Statement No: 967

RECOMMENDED ENVIRONMENTAL CONDITIONS**STATEMENT THAT A PROPOSAL MAY BE IMPLEMENTED
(PURSUANT TO THE PROVISIONS OF THE
ENVIRONMENTAL PROTECTION ACT 1986)****LUMSDEN POINT GENERAL CARGO FACILITY**

Attachment 1 to Ministerial Statement 967

Change to proposal approved under section 45C of the *Environmental Protection Act 1986*

Figure 1: Lumsden Point General Cargo Facility Development Envelope and Dewatering Discharge Location

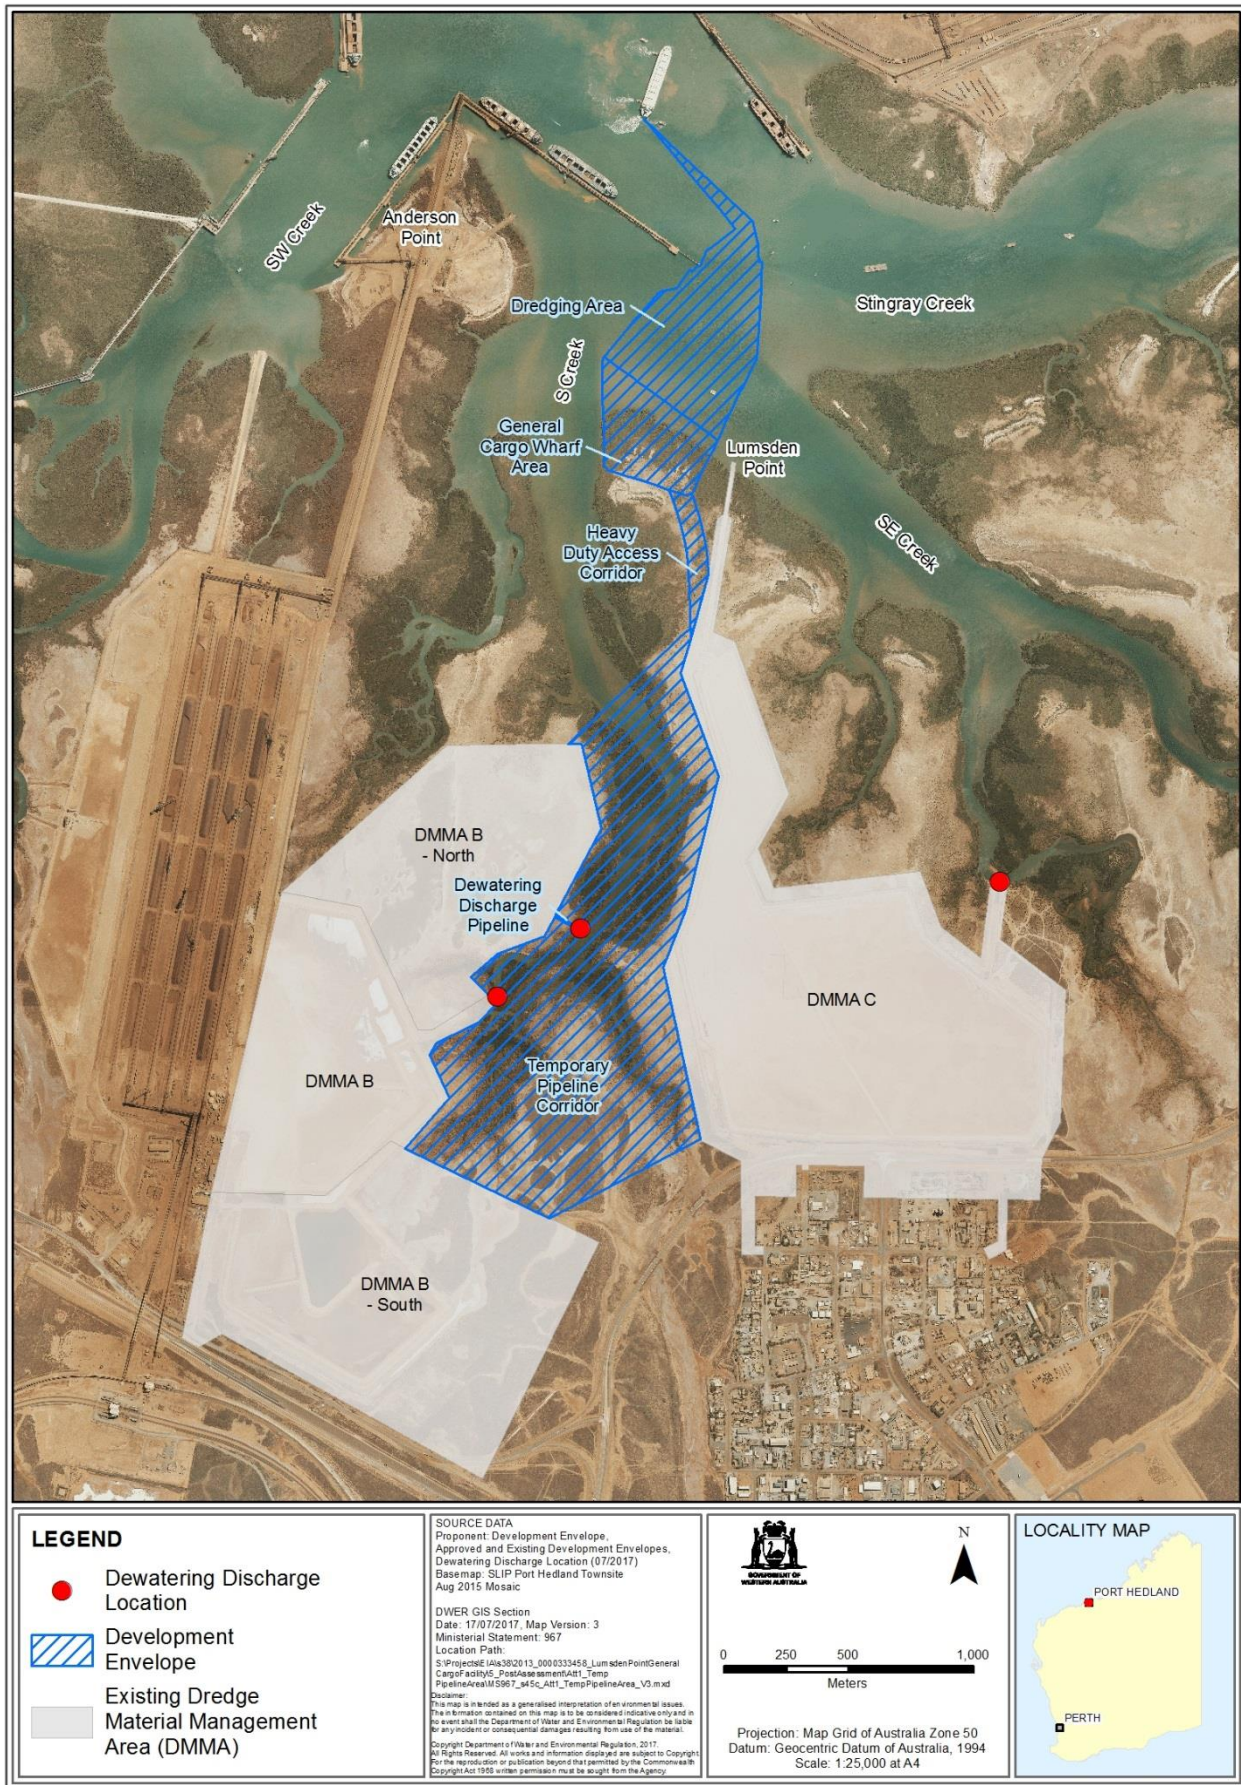
- Include a 139.46 hectare development envelope for the temporary pipeline corridor;
- Include DMMA B as a location for dewatering discharge; and
- Update Figure 1 and delineation coordinates.

List of Replacement Figures – Figure 1 is deleted and replaced with the following:
